COVER SHEET
SANITARY SEWER PLANS

WOODSIDE RIDGE
FIRST PLAT

LEE'S SUMMIT, MO

AS BUILT
Date Surveyed: 04-20-2020

NSI Certified of Authority #031892
300 RUPPING ST. SUITE 100
NORTH KANSAS CITY, MO 64116
TEL 816.861.1177
WWW.OLSSON.COM

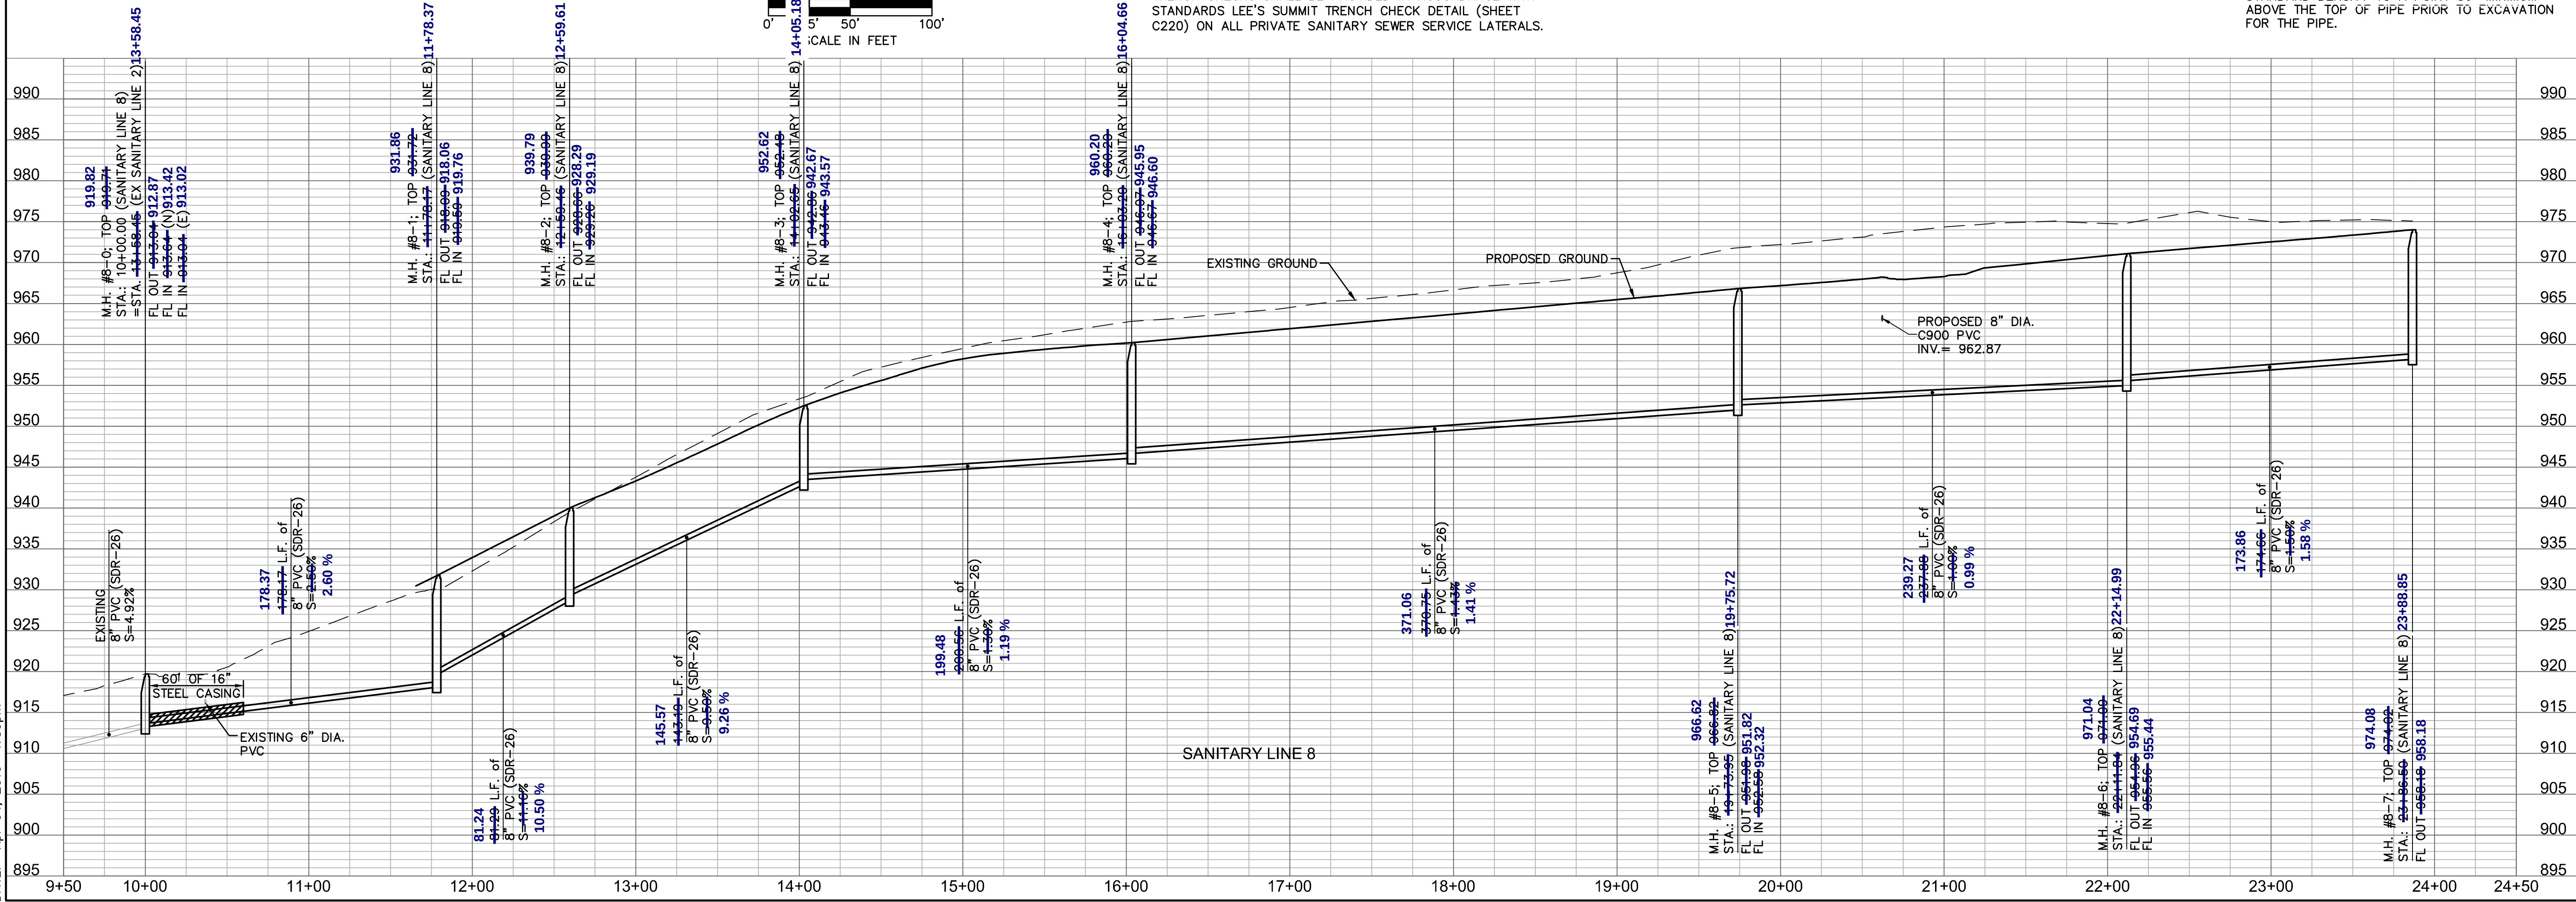
As-built is 0.56' S and
1.90' W of plan
M.H. #10-3, CONST. STD.
SANITARY MANHOLE (4' DIA. INSIDE)
STA.: ~~11+97.22~~ (SANITARY LINE 10)
=STA.: ~~10+63.37~~ (C) ~~10+62.72~~
NW KAYLEA COURT, ~~5.01'~~ RT ~~4.04'~~

As-built is 0.65' N and
1.18' E of plan
M.H. #10-4, CONST. STD.
SANITARY MANHOLE (4' DIA. INSIDE)
STA.: ~~12+54.90~~ (SANITARY LINE 10)
=STA.: ~~11+19.97~~ (C) ~~11+20.67~~
NW KAYLEA COURT, ~~16.06'~~ RT ~~18.11'~~

As-built is 3.02' N and
1.42' E of plan
M.H. #10-5, CONST. STD.
SANITARY MANHOLE (4' DIA. INSIDE)
STA.: ~~11+46.12~~ (SANITARY LINE 10)
=STA.: ~~13+10.90~~ (C) ~~13+13.98~~
NW KAYLEA COURT, ~~27.55'~~ RT ~~28.84'~~

As-built is 3.95' N and
0.50' W of plan
M.H. #10-1, CONST. STD.
SANITARY MANHOLE (4' DIA. INSIDE)
STA.: ~~10+51.92~~ (SANITARY LINE 10)
N: ~~1,003,081.4947~~ ~~1003085.45'~~
E: ~~2,812,310.1740~~ ~~2812309.68'~~
